Review of the Department of Energy's Plans for Disposal of Surplus Plutonium in the Waste Isolation Pilot Plant (2020)

Committee on Disposal of Surplus Plutonium at the Waste Isolation Pilot Plant;
Nuclear and Radiation Studies Board; Division on Earth and Life Studies;
National Academies of Sciences, Engineering, and Medicine

Committee on Disposal of Surplus Plutonium at the Waste Isolation Pilot Plant

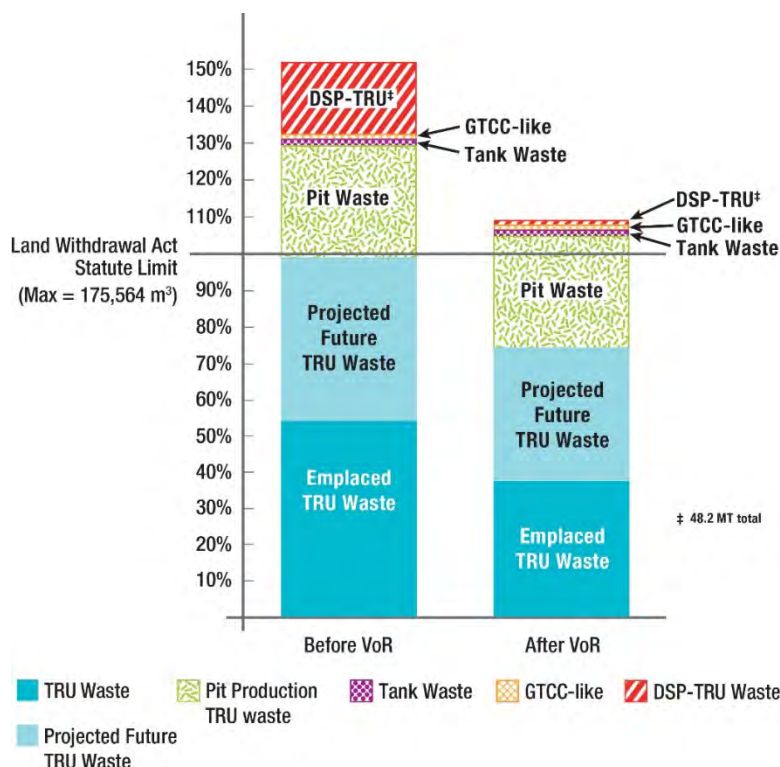
However, the data in Table 3-2 and Figure 3-9 make clear that LWA statutory capacity remains an issue, primarily due to pit production TRU waste. In fact, the impact of the DSP-TRU waste on other wastes is miniscule—which represents ~1 percent of the LWA capacity (or 2,057 m³)—but the impact of other wastes on DSP-TRU is large. The committee's recommendation to prioritize DSP-TRU waste and to reserve space in WIPP remains valid—especially since DOE has made similar agreements for pit production TRU waste and guaranteed shipment rates from Idaho.

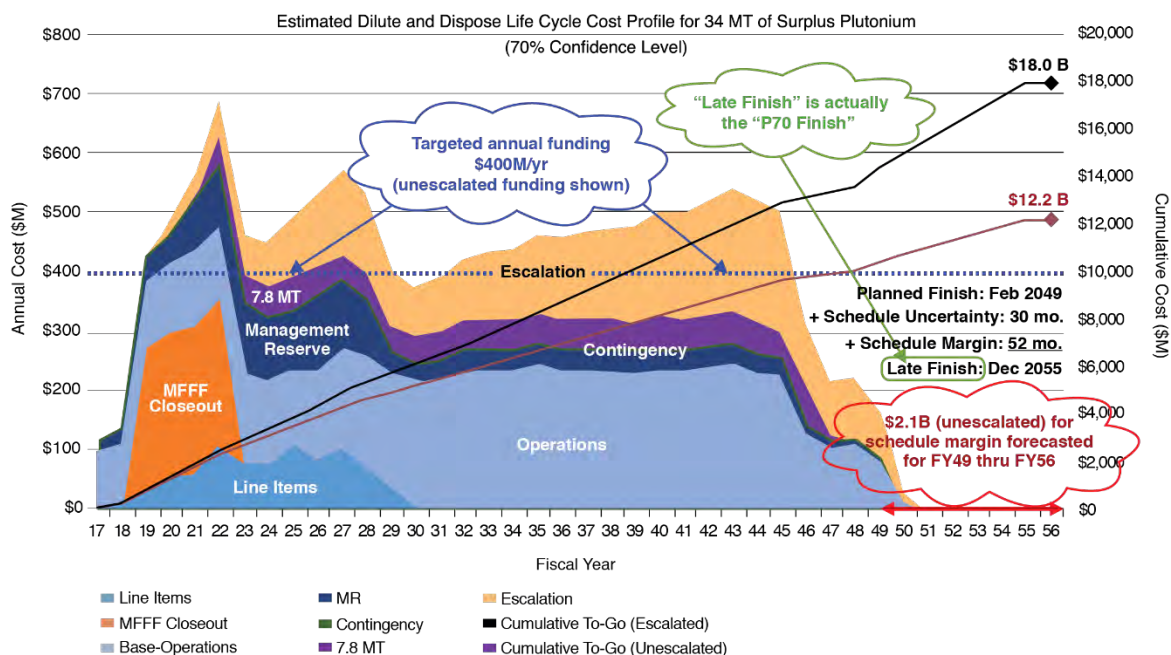
An independent review of DOE-NNSA's approach to the LCCE by USACE estimated an end date of at least FY 2056 when contingencies are taken into account; the USACE report states that the dilute and dispose “program finish date does not align with mission requirements” (SRNS, 2018a, fig. 4; USACE, 2018, p. i).⁵ See Figure 4-2.

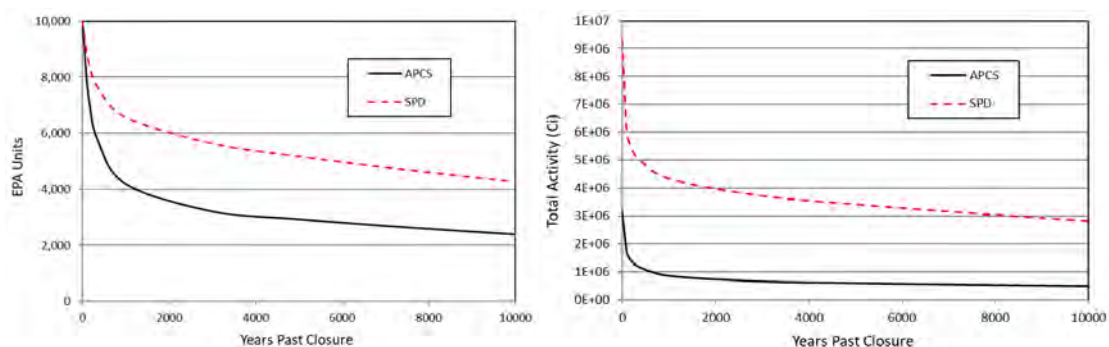
To illustrate these characteristics, the committee points to the nominal baseline performance assessment (which does not include any portion of the 48.2 MT), referred to as the APCS (Abandonment of Panel Closures in the South) performance assessment (PA).¹² Figure 5-1 shows the effect of adding surplus plutonium disposition (SPD) inventories (48.2 MT) to the EPA units¹³ and the total radioactivity in WIPP, both plotted as a function of time through 10,000 years. The SPD inventory increases the EPA units by a factor of 2 and increases the long-term radioactivity by nearly a factor of 4.¹⁴

Table 5-3 shows that the combined SPD waste streams, SR-KAC-PuOx for the 6 MT and SR-KAC-SPD for the 42.2 MT, will occupy 19 percent of the total physical volume (measured by the outer container) of WIPP and will account for 85 percent of the plutonium-239 emplaced in WIPP (Dunagan, 2019).

FIGURE 5-2 Results of criticality analysis with boron carbide (B_4C) added to the diluted plutonium oxide contained within the 6-inch-diameter inner pipe of the criticality control container (see Figure 1 in Box 2-1). SOURCE: Saylor and Scaglione, 2018, fig. 9. ORNL/TM-2017/751.

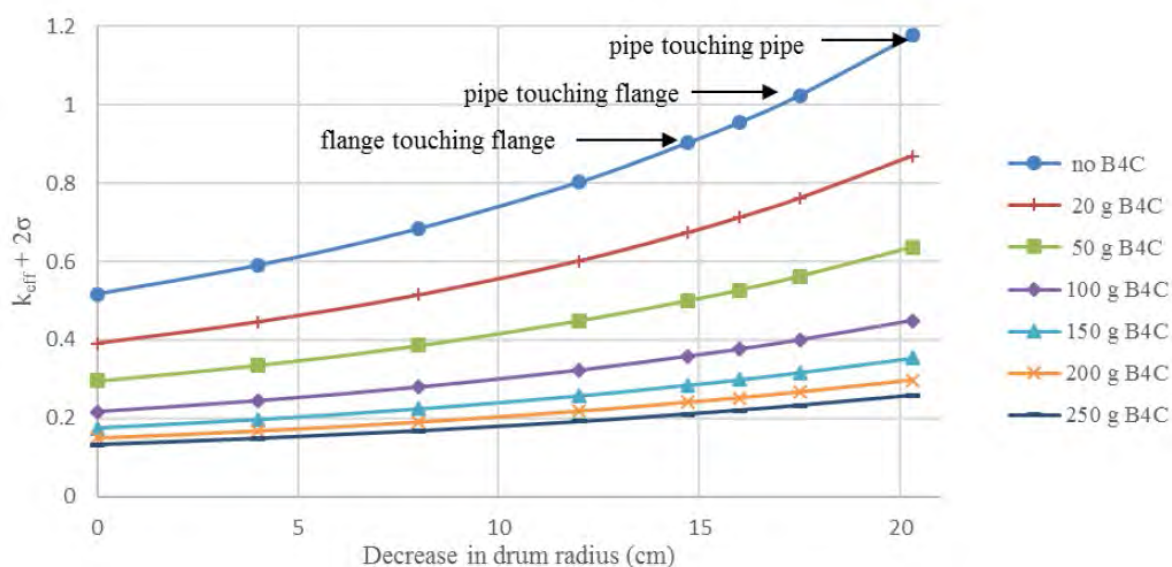
The ORNL nuclear criticality assessment developed models for optimally configured (i.e., an optimal environment for criticality), infinite arrays of CCC/CCOs that contain the maximum allowed quantity of DSP-TRU residing within an optimal environment for conservative results. Criticality occurs when the effective neutron multiplication factor is greater than or equal to unity ($k_{\text{eff}} \geq 1$). The ORNL models predicted $k_{\text{eff}} > 1$ if the inner containers (pipes) in the infinite array were moved together (see top curve of Figure 5-2). To remove the potential for criticality ($k_{\text{eff}} \geq 1$), it was determined that boron carbide (B_4C) additive needed to be included as part of the overall mix of plutonium oxide and adulterant. The addition of boron carbide readily removes the potential for criticality as seen in Figure 5-2.¹⁷

While the committee concurs with the approach and conclusions of the nuclear criticality assessment report, the principal issue here is that concerns over post-closure criticality are renewed (particularly beyond the 10,000-year regulatory period), and DOE would be best served if such reports were made publicly and widely available.
